**SITE PLAN REVIEW SHEET  
ENVIRONMENTAL VARIANCE REQUEST ONLY**

**CASE:** SP-2019-0253C

**PROJECT NAME:** Springdale Farms

**Staff Findings of Fact**  
**Variance to LDC 25-8-261**

Exhibit 1: Springdale Farms SP-2019-0253C – Overall Site Plan

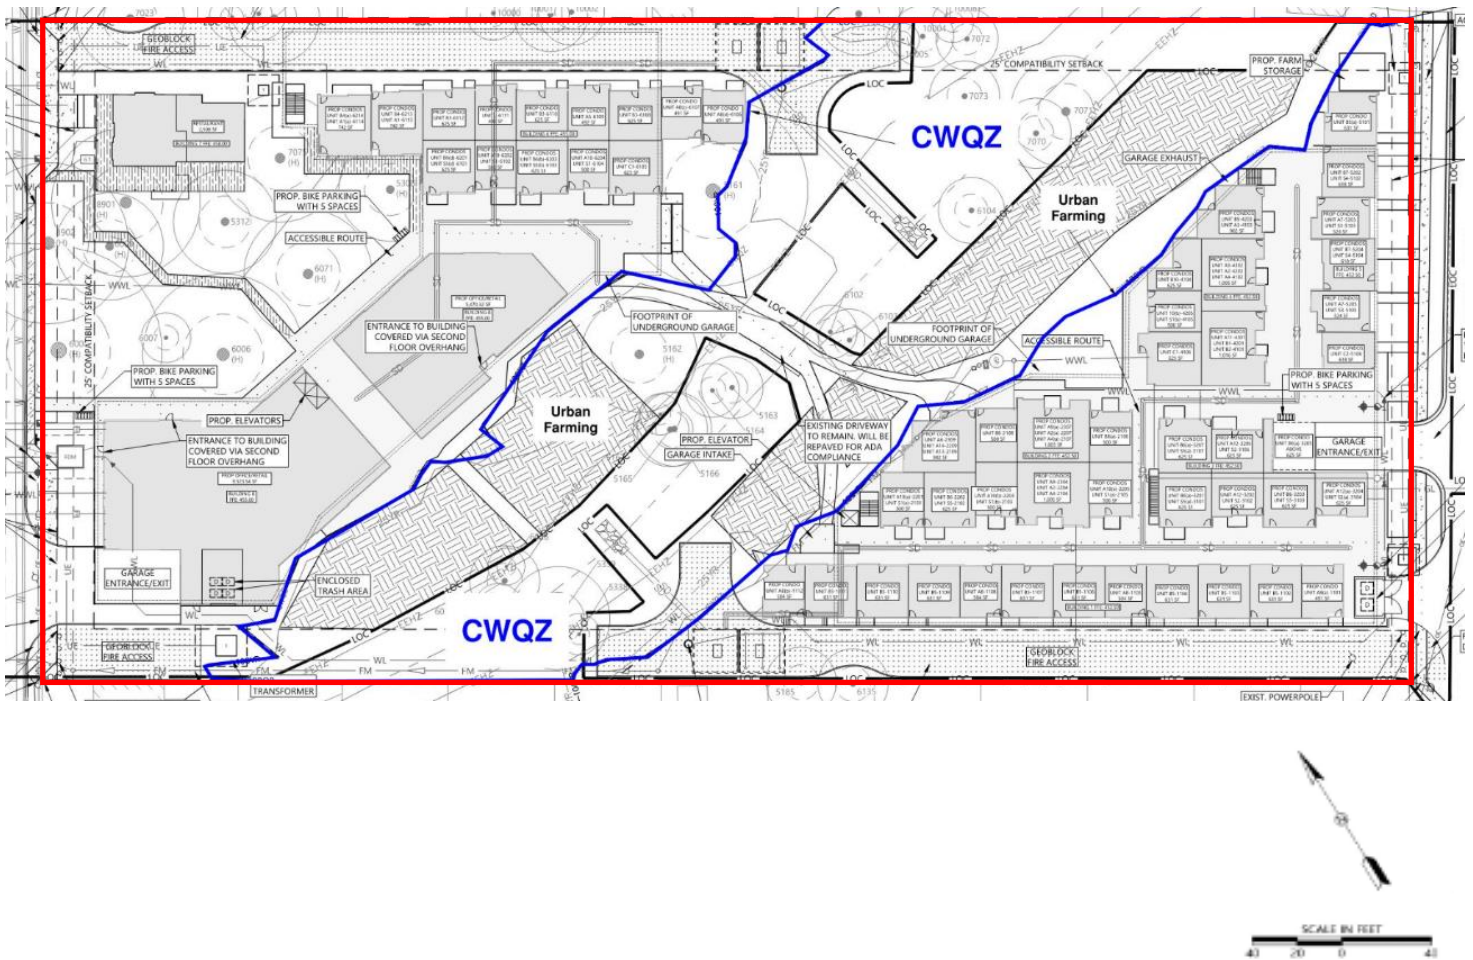
No Due to the scale of the project to maximize development, the applicant has made a design choice to make use of the CWQZ to address Austin Fire's code requirement for the hammerheads, which are not allowed by the Land Development Code. Moreover, to increase building square footage, there will be building overhangs over the CWQZ, creating rain shadow effect that would deprive the CWQZ of necessary rainfall and sunlight. The scale and design decisions do not provide greater overall environmental protection. See Exhibit 1 – Overall Proposed Site Plan.

- No In addition to the building overhangs within the CWQZ, the hammerheads encroach on both sides of the CWQZ. Development is prohibited within the CWQZ except as provided in LDC 25-8-261 which doesn't include the stated development, thus requiring the need for a variance from the Land Development Code.

- c) Does not create a significant probability of harmful environmental consequences.
- No The building overhangs and hammerheads within the CWQZ would deprive the CWQZ of rainfall and sunlight penetration that are necessary for riparian health, and adding impervious cover and development to the CWQZ where there wouldn't be otherwise. Furthermore, there would be removal of native vegetation and topsoil.

- 3. Development with the variance will result in water quality that is at least equal to the water quality achievable without the variance.
- No There would be impervious cover and development within the CWQZ where there wouldn't be otherwise. The impervious cover from the building overhangs would not be draining to the water quality pond.
